WORCESTER TOWNSHIP PLANNING COMMISSION MEETING MINUTES JUNE 25, 2026

Reference: BT Worcester, LLC – City View Land Development
Final Plan Review – First Review
TMP No. 67-00-01606-00-1

LICENSED PROFESSIONAL ENGINEER STATE OF PA LICENSE NO. PE076664	
BT WORCESTER, LLC	CITY VIEW - APN #67-00-01606-001 2974 GERMANTOWN PIKE, WORCESTER TOWNSHIP, MONTGOMERY COUNTY, COMMONWEALTH OF PENNSYLVANIA
TREE SURVEY PLAN

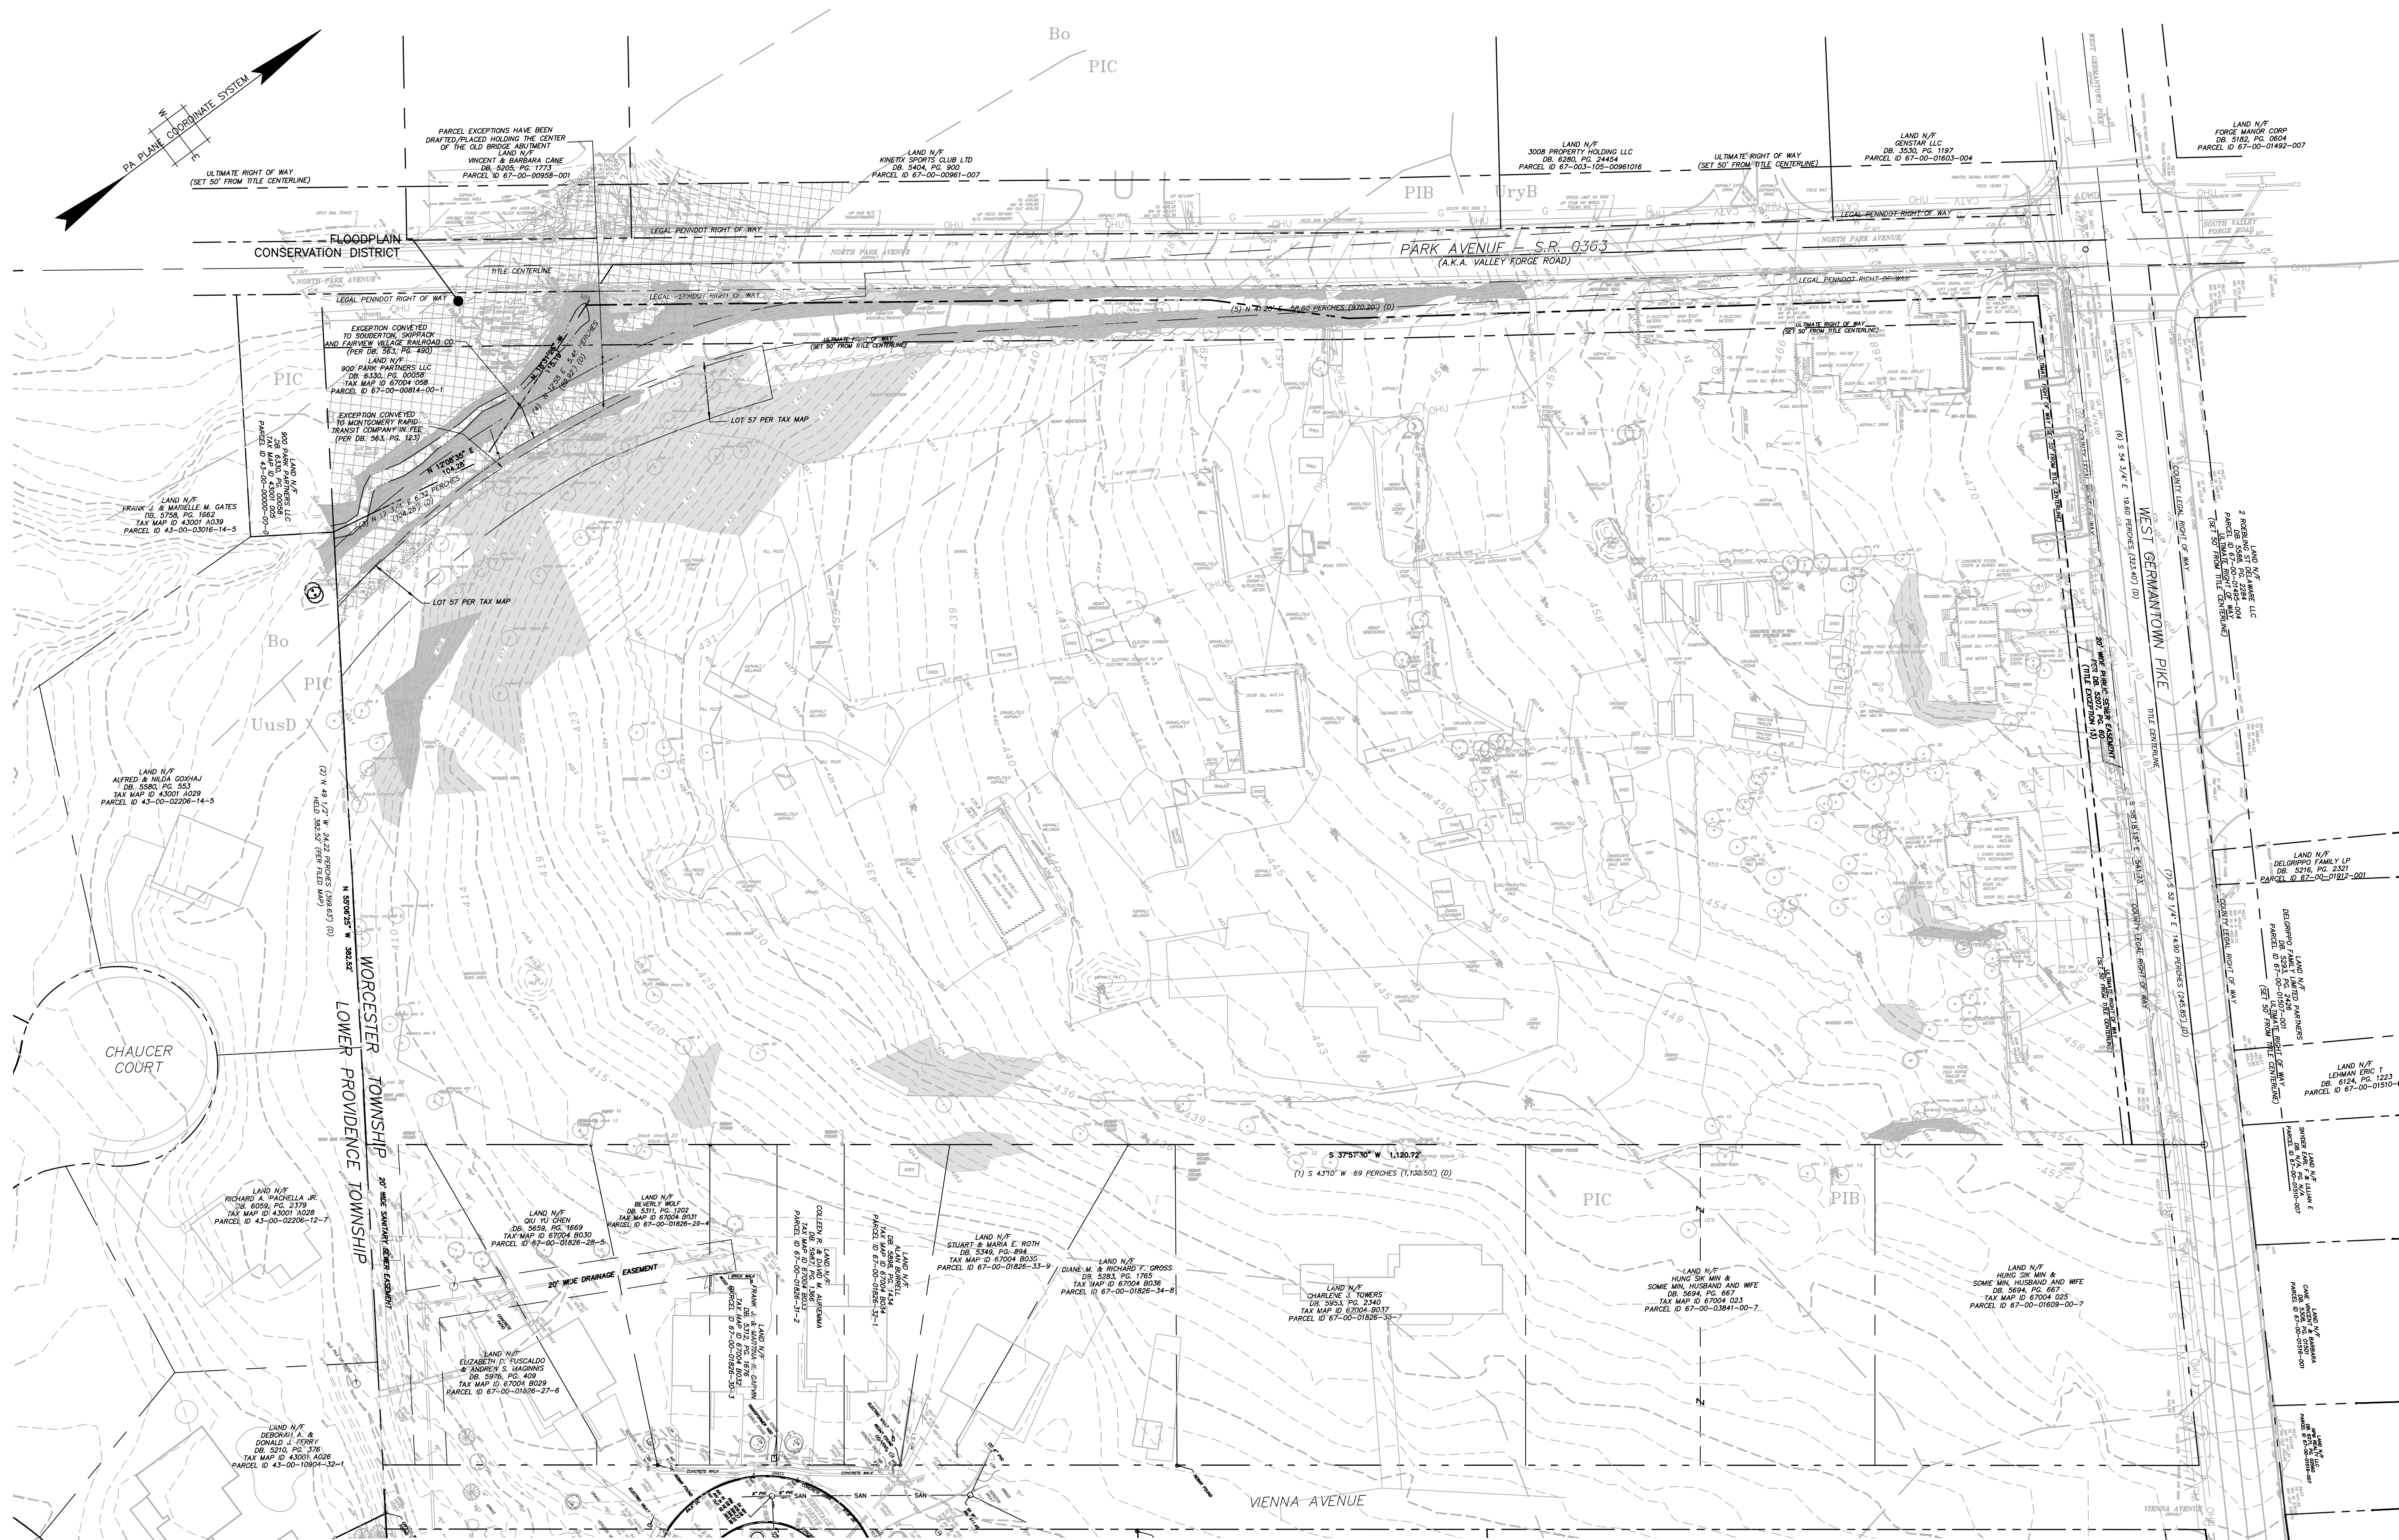
9. Landscape table shows 227 existing trees, 174 removed, 117 replacement trees required, and only 90 proposed. The plans indicate that 27 trees are to be planted offsite. The Applicant must coordinate with the Township regarding locations of off-site planting areas. (130-28.F(7) & 130-28.F(7)(b)[2])
